New Hotel – Home 2 Suites Hilton
550 Gateway Blvd.
September 20, 2017

City of South San Francisco – **FIRST REVIEW**
City Permit No.: B17-1420
WC³ Project No.: 217-411- 225
Page 23

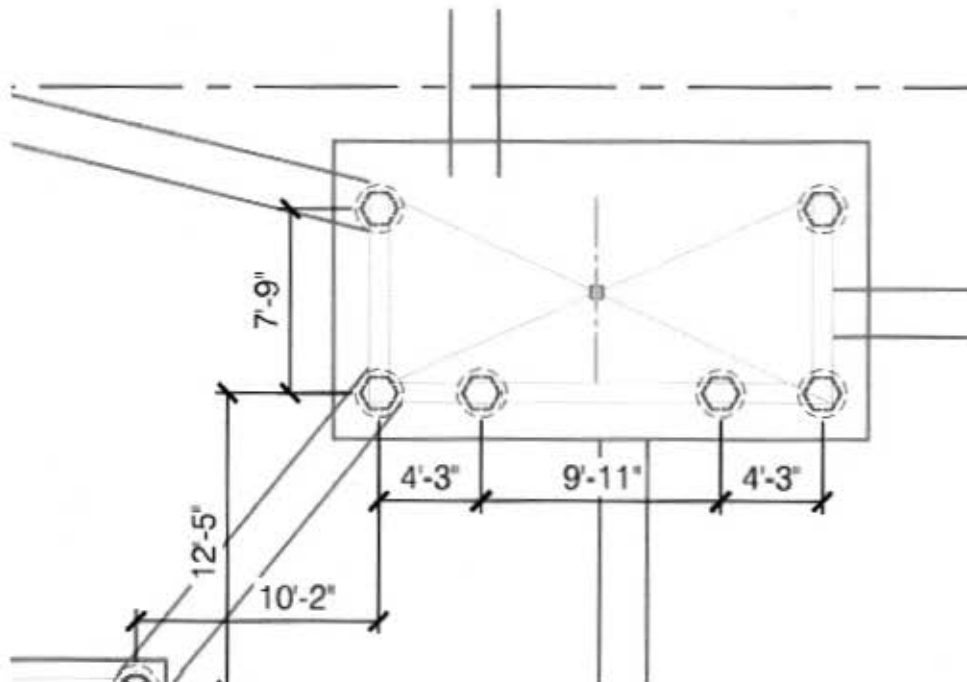
S33. Please provide calculations and information to clarify how building irregularities per Table 12.3-1 and 12.3-2 of ASCE 7-10 have been addressed.

- a) Provide a deflection analysis to verify if the building contains a torsional or extreme torsional irregularity. (*The Torsional Analysis of Rigid Diaphragms starting on Page 42 of the Calculations does not appear to address this.*) Please be aware that Per Section 12.3.3.1 of ASCE 7-10, this building is not allowed to have an extreme torsional irregularity.
- b) Please clarify how reentrant corner irregularities have been addressed.

- S33a.** See revised calculations added on page 46.1 to 46.2.
- S33b.** See revised calculations added to page 46.7 to 46.10 and sheets S-2.2 and Detail 20/ S1.1.

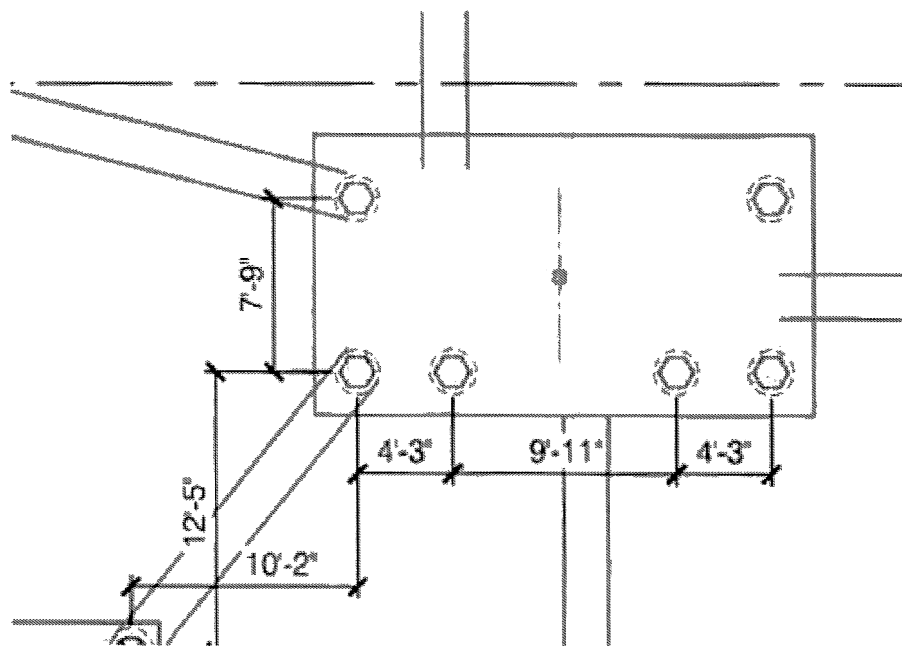
- F11. Provide calculations for the foundation (pile cap) between grid line L & H and grid line 5 & 14 supported by six (6) piles.
- F12. Sheet DDP-2.1: Please clarify how the grade beams will be framing into pile cap mentioned shown below.

- F12) ADD DETAIL 11/SD1.2.
- F13) THE REFERENCED DETAIL HAS BEEN UPDATED
- F14) CORRECTOR.
- F15) CORRECTOR - THIS IS FOR A 3-PILE SYSTEM. CRITICAL
DIMENSIONS FOR ANALYSIS IS BASED ON TRIANGULAR
DISTRIBUTION, HOWEVER, SQUARE SHAPE IS SHOWN
ON PLANS SINCE IT MAKES CONSTRUCTION EASIER.

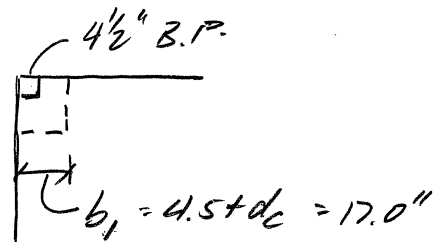
- c) Please provide detail of boundary element showing near edge and not near edge of footing. Cannot find such detail in the package.
- S18. Clarify if the adequacy of the reinforcement was checked against the compressive/tensile force indicated on the superstructure plans framing into the corners or edges of the concrete slab. Details at 6/SD1.2 are for edges but not for the corner. Please include a plan to show the layout of the reinforcement. Provide calculations to check the adequacy of the reinforcement provided.

S-18) ADDON DETAIL 12/SDI.1 FOR SLAB CORNER REINFORCING
AND REVISION DETAIL 6/SDI.2

CHECK PUNCHING SHEAR AT CORNER:

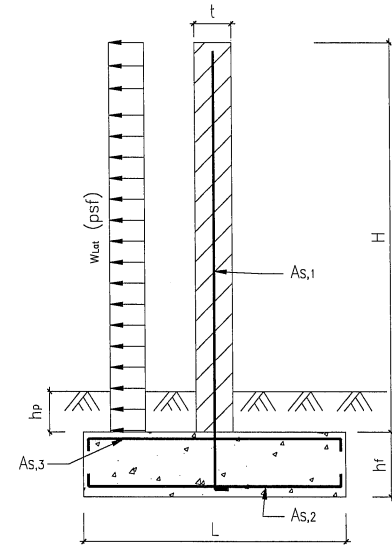
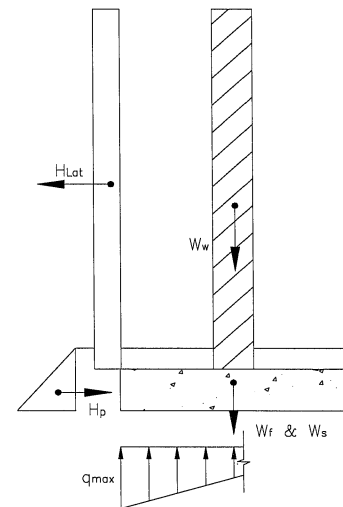
- S7. Provide structural calculations for the masonry wall and it's foundation for the trash enclosure as shown on detail K12/A2.2.

- S6. Added note #22 to reinforcing notes on sheet SN-1
- S7. See attached trash enclosure calculations and detail 27/SD-2
- S8. Detail 1/E6.1 does not apply and has been deleted.
